Delegated Report

Householder Planning Application

Planning Application No: 20240802

Location: 103 Jubilee Crescent Gravesend Kent DA12 4JQ

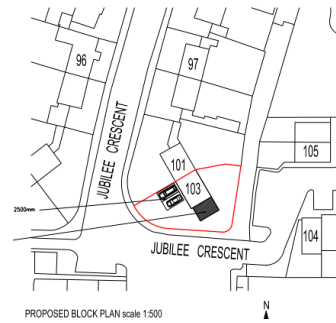
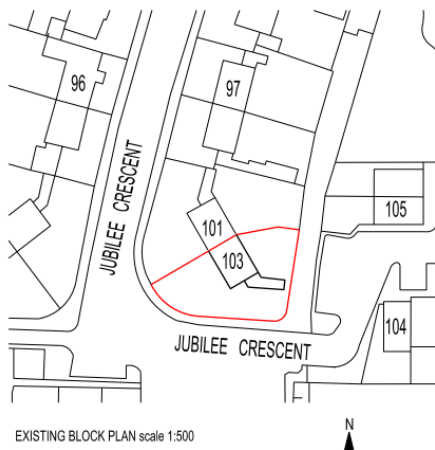
Proposal

The proposal seeks to erect a two storey side extension to form an additional kitchen, family room, wc and bedroom with ensuite at first floor. The proposal also seeks to create a hardstanding to facilitate two parking spaces in the front garden.

Proposed Parking Plans

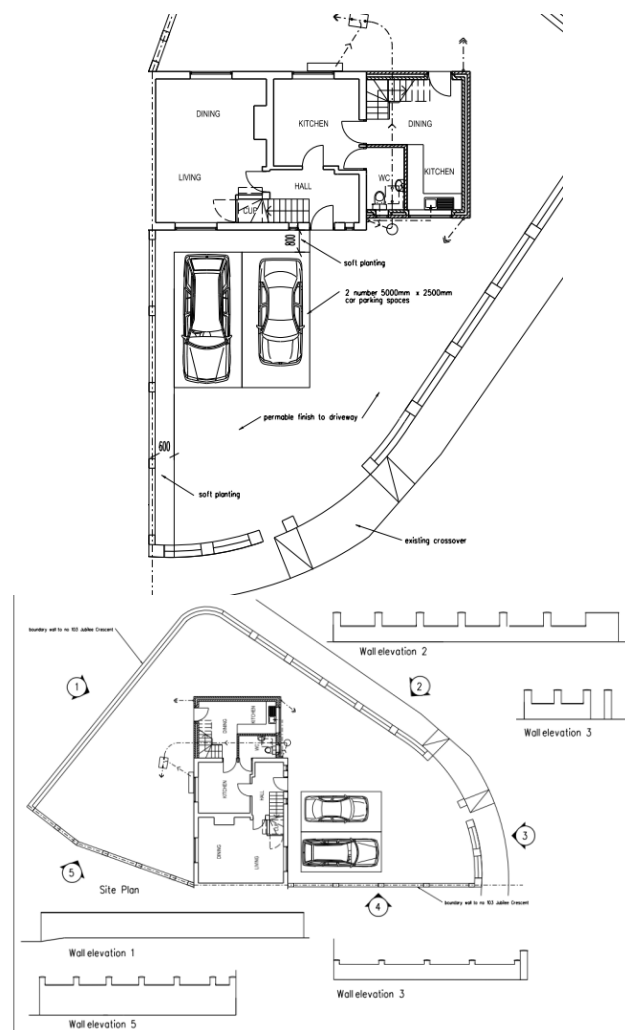
The proposal also seeks to create two vehicle parking spaces, the garden frontage will include a large section of permeable paving with some soft planting. During an officer site visit it was noted that there has already been some work carried out to the property frontage which includes the erection of a prominent

The proposed parking would result in a vast reduction of soft landscaping and the installation of a substantial hardstanding which would result in a harsh developed appearance which diminishes the positivity which soft landscaping provides. The boundary wall with the piers are a stark contrast to the wider streetscene which is characterised by low levels wall and soft landscaped frontages.

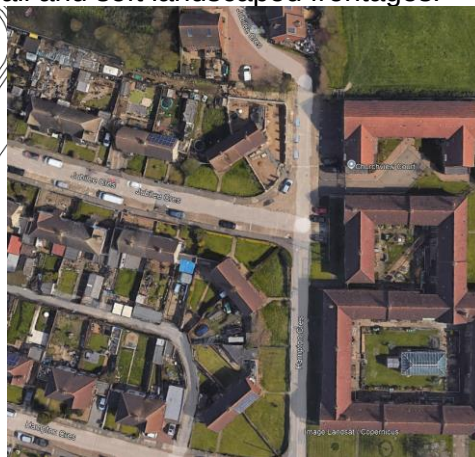
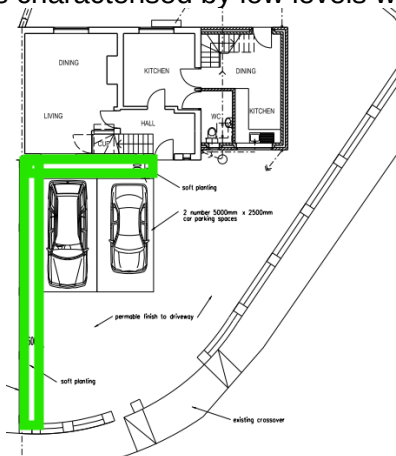
The previously refused scheme proposed a 4.6m wide side extension, this has now been reduced to a 3.65m extension.

The applicant has reduced the width of the extension by 1m, the extension is still large, however, it is considered that this would be acceptable provided that no further extensions are added to the site. If permission is forthcoming a condition would be imposed to ensure that Classes A, B and C permitted development rights are removed to safeguard the character of the dwelling and wider area, as well as protecting future occupant amenity. The extension is set down and behind the principal elevation and has been designed to demonstrate subservience.

It is considered that the revised proposal complies with the guidance and whilst large is acceptable in terms of scale and design.

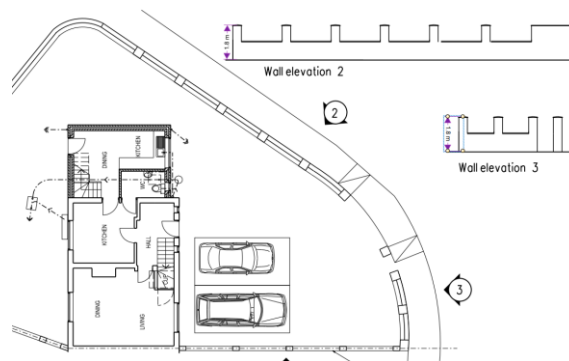
It should be noted that *Pedestrian visibility splays are generally 2m x 2m and are measured down the side of the driveway and not from the centre of the drive or a vehicle parked on the drive.* Below is a diagram from the Council's adopted design guide.

Pedestrian visibility splays should be protected and there should be no landscaping or boundary treatment exceeding 850mm in height within a 45°, 2m base triangle either side of the driveway and no boundary wall, fence or other means of enclosure or obstruction exceeding 0.6m in height within the visibility splays.

The proposed boundary wall as can be seen below has a height of 1.8m which is significantly above the required standards and so it is considered that the proposed boundary treatment poses a significant highway hazard to road users and pedestrians alike.
